# London Luton Airport Expansion

**8.176 Applicant's Response to Comments From the  
Highway Authorities on the 'Accounting for Covid-19 in  
Transport Modelling Final Report' (AS-159)**

Document Ref: TR020001/APP/8.176

Figure 1 2043 PM Without Expansion - Updated

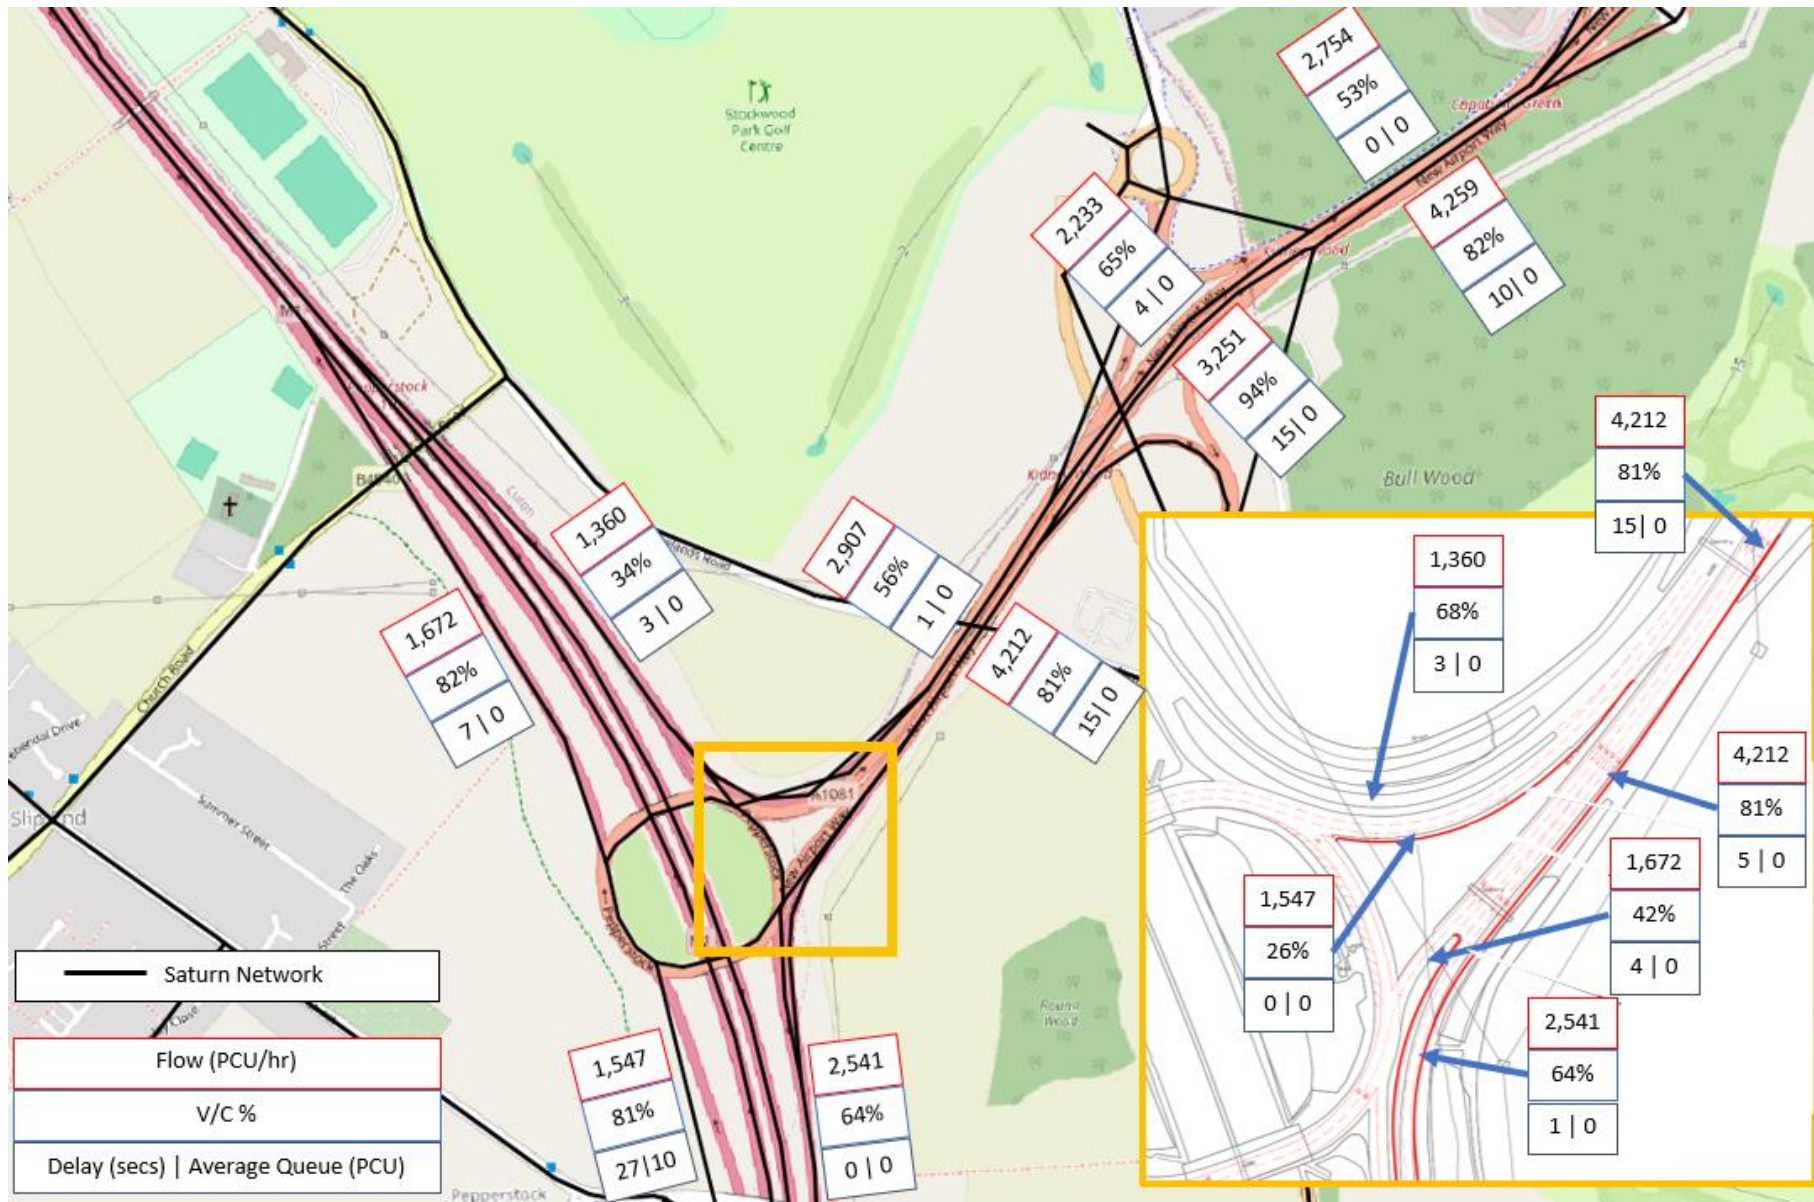
5.2.3 National Highways expressed concerns in relation to the traffic approaching M1 Junction 10 from the east via A10181 in the PM peak for the 2043 forecast year, and requested further information in relation to flows, queues and delays. This, to have a "*more comprehensive understanding of traffic conditions on the approach to Junction 10*".

5.2.4 The Applicant notes National Highways concerns, and provides further detailed information of the A1081, as shown in Figure 1 and Figure 2.

5.2.5 The figures show that the average modelled queues are low in the region surrounding M1 Junction 10. The average queue is zero PCU (Passenger Car Unit) at all locations except for the M1 Junction 10 northbound off slip which reduces from 12 in Core to 10 in Expansion.

5.2.6 In terms of V/C ratios, the highest V/C is through Junction 10a in the With Expansion scenario (94%) which is an increase of around 550 vehicles from the core scenario with a flow of 2,700 PCUs per hour and 78% V/C. The traffic volumes at other locations do reach levels of over 80%, with the largest differences observed on the westbound movement on the A1081 approaching M1 Junction10.

Therefore, no road links approaching M1 Junction 10 from the east are forecast to experience any excessive queuing or delays, and hence would not restrict traffic routing via M1 Junction 10.

Figure 3 Without Expansion Demand Model Convergence

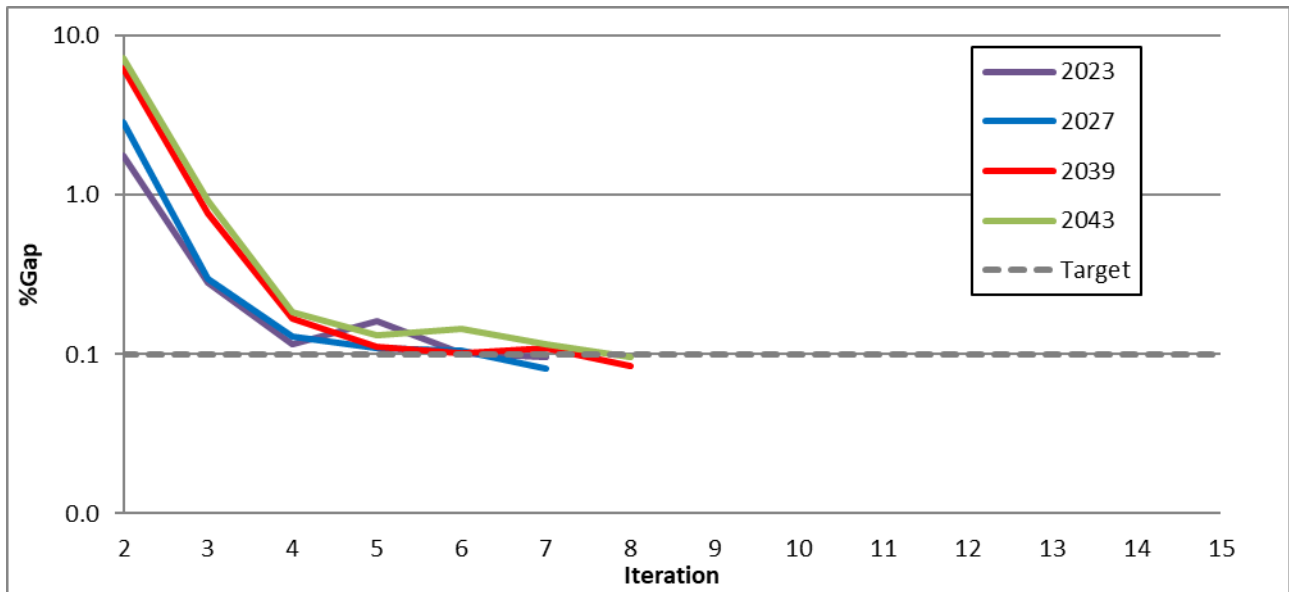
- 5.2.32 National Highways requested information on the model convergence.
- 5.2.33 For the original modelling runs, the convergence was reported in Section 4.4 for the Without Expansion scenario, and in Section 5.2 for the With Expansion scenario in **Strategic Modelling Forecasting Report (Appendix F of the Transport Assessment [APP-201])**, where these were reported in Table 4.14 and Figure 4.11 for the demand model convergence, and Table 4.15 for the highway assignment model. Whereas for the Without Expansion scenario, these were reported in Table 5.1, Figure 5.1 and Table 5.2.
- 5.2.34 For the updated runs, these are reported in this document below as Table 5, Figure 3 and Table 6 for the Without Expansion scenario, whereas Table 7, Figure 4 and Table 8 showing the With Expansion scenario.

Figure 5 Location of southbound merge markers

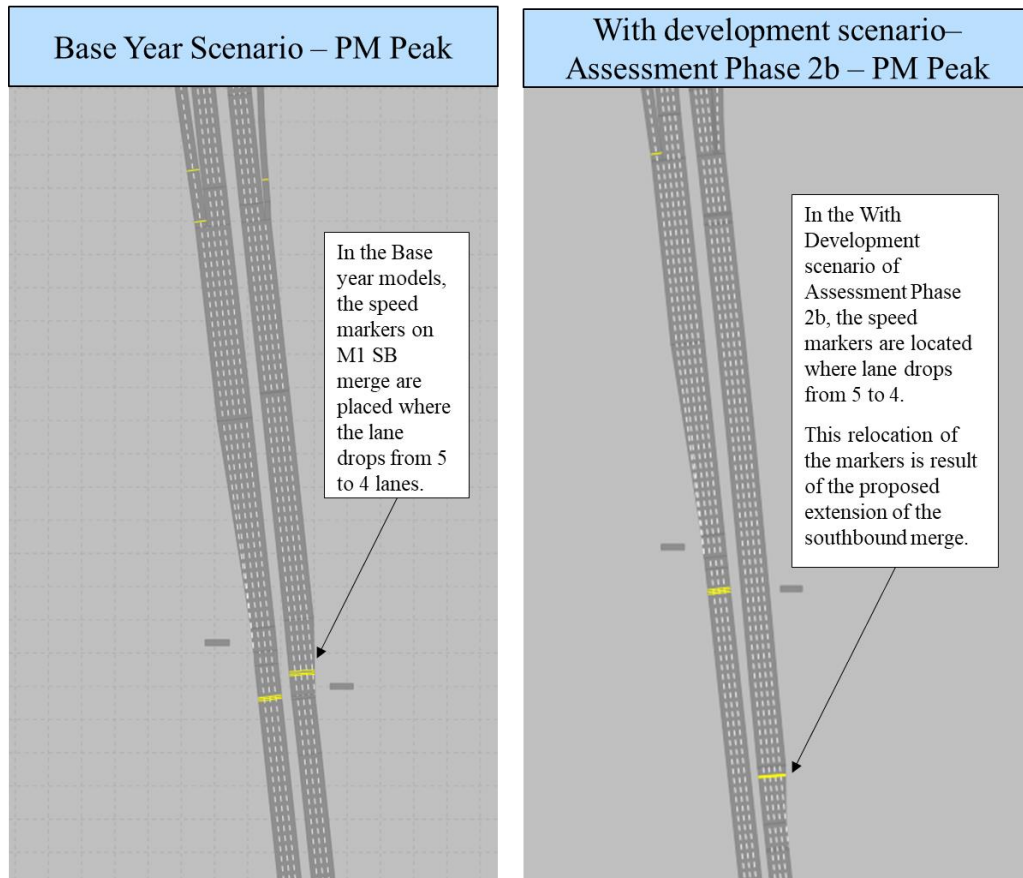
#### ***M1 southbound merge***

- 5.3.3 The location of the desired speed decision on the southbound merge in the With Development scenario is consistent with the location in the validated Base year model. As depicted in the figure below, the decision speed markers in the Base year model are positioned where the number of lanes drops from 5 to 4.

- 5.3.4 In the With Development scenario, the southbound merge is improved and extended 150m to the south, and as result shifting the lane drop location by the same distance. Therefore, the desired speed decision markers are also relocated southward.

- 5.3.5 Furthermore, there is only a slight difference in the speed of the markers on M1 mainline upstream of J10 (55 mph in peak hour) and the speed markers on the southbound merge (53 mph in peak hour). Therefore, the Applicant expects that any change in the position of speed markers is anticipated to have minimal or no impact on the performance of the southbound merge.
